CERTIFICATE OF APPROPRIATENESS

Property: 714 Woodland Street, lot 3, tract 4A, block 36, Woodland Heights Subdivision. The property includes a historic 2,491 square foot, one and half story wood frame single-family residence situated on a 7,500 square foot (75' x 100') interior lot.

Proposal: Alteration – The applicant received partial approval at the November 2014 HAHC meeting for alterations to the existing full width front porch. The applicant proposed to apply a brick facing to the existing concrete porch deck and concrete steps, the brick facing was denied.

The applicant is now requesting approval to construct brick wing walls on the side of the concrete steps and apply a brick facing to the concrete steps.

NORTH ELEVATION – FRONT FACING WOODLAND STREET

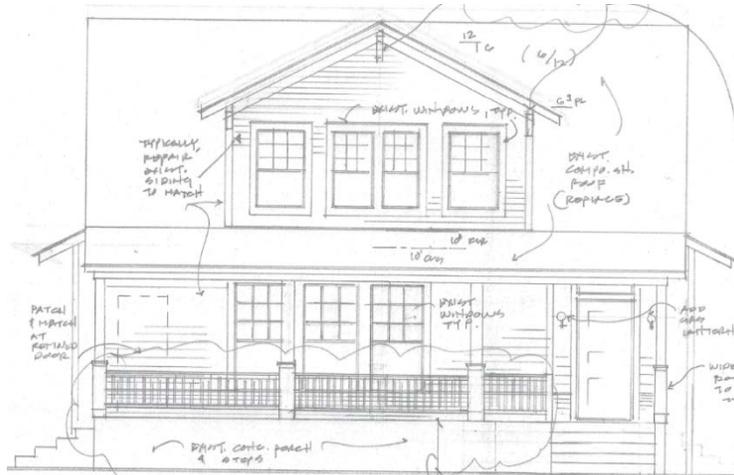
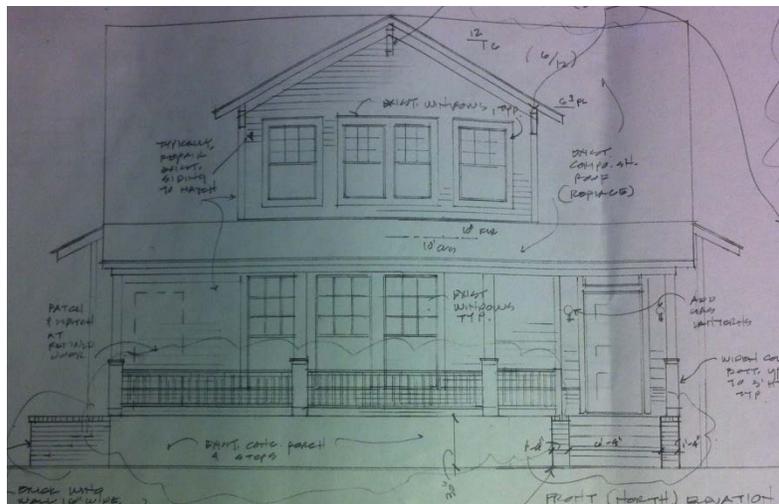
<i>The application of the brick facing to the existing concrete steps creates a false sense of history by introducing an architectural feature that has never been present on the residence.</i> |

<i>Brick facings on steps are not typical of contributing residence in the district. The typical condition found in the district is either wood porch decks with either wood or concrete steps or a concrete porch deck with concrete steps.</i> |

Approval of the brick wing walls on the side of the concrete steps located on the north and east elevations.

Denial of the application of the brick facing to the concrete front porch steps.

EAST SIDE ELEVATION

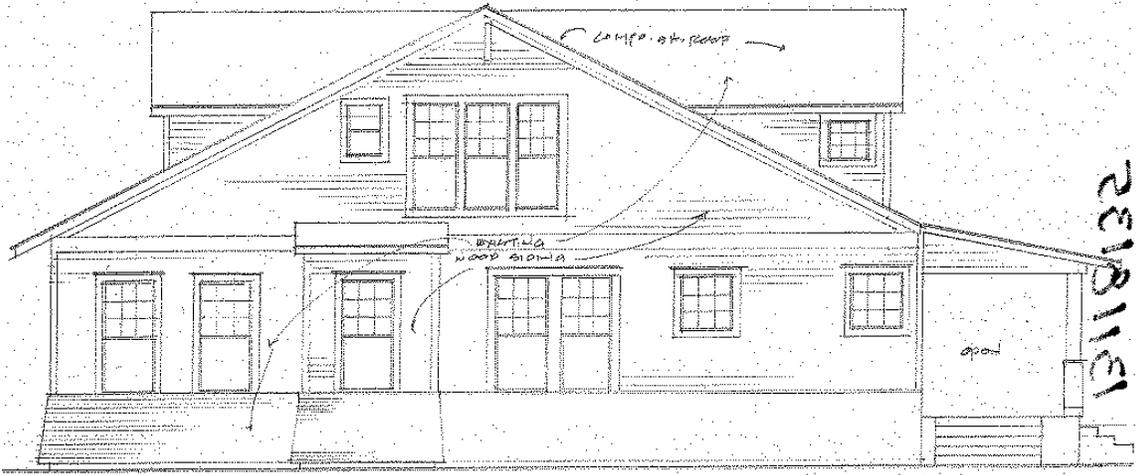
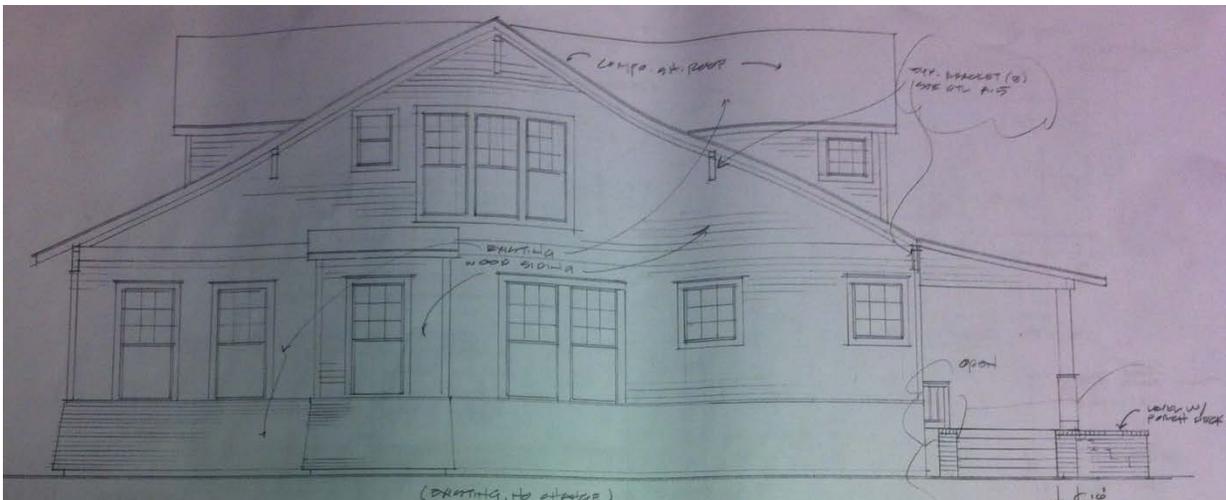
Exterior Materials: The residence features a full width front porch with a concrete porch deck and concrete steps. A brick facing will be applied to the concrete steps and brick wing walls will be constructed on the sides of the concrete steps located on the north and east elevations. The proposed wing walls will measure 1'-4" wide, 4' deep, and 30" in height.
